Building Conservation comments

File Ref: 25/00427/FPH & 25/00428/LBC

Address: Gannock Green Farmhouse, Gannock Green, Gannock Road, Sandon, Buntingford, Hertfordshire, SG9 0RH

Subject: Erection of porch canopy and metal railings to entrance steps.

Examples of similar porches to the one proposed

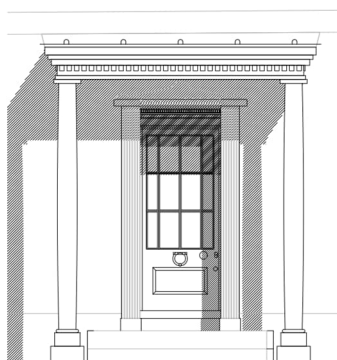
- 4.3 At page 7 of the DAHS the image below centre is offered as an example of what exist on a similar type of house. My hesitation with supporting this approach is that Gannock Green Farmhouse is described as a large house with C16 origins which was remodelled in the early C18 and then extended and altered C19. As a farmhouse that has been ‘Georgianised’, what Gannock Geen Farmhouse is not a purposely designed Georgian house such as found at the former Ashwell Vicarage below right which is described as a circa 1830 house with ‘square projecting porch with 2 Greek Doric columns, a plain entablature and a thin shallow pedimented cornice’.

Current photograph of the entrance showing the dentil course and shallow pediment as mentioned in the listing

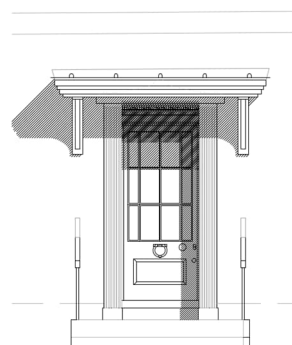
- 4.4 The proposed open sided porch canopy supported on Tuscan columns is certainly not poor design, quite the contrary, it is a well-designed statement entrance feature that would not occasion harm as such to the listed building. The question I raise is whether a simplified covered entrance canopy could be achieved that would perhaps respect the farmhouse's historic narrative more fully. I am also concerned that if application ref: 25/00430/FPH for the 'Erection of detached two bay cart lodge' is consented that the proximity of the cart lodge alongside the projecting porch may result in an overly busy frontage.

- 4.5 The architect agreed to explore the potential for something a little more modest (below right) which was received today. As the architect says, *"I think this is quite successful, and by absorbing the existing relief pediment into the new canopy depth, the canopy appears to be part of the door surround"*.

- 4.6 In my opinion, the alternative and somewhat understated canopy set on curved gallows brackets in the image above right enables the canopy to relate better with the fluted pilasters, would not be as high or project out as far and is considered more acceptable.
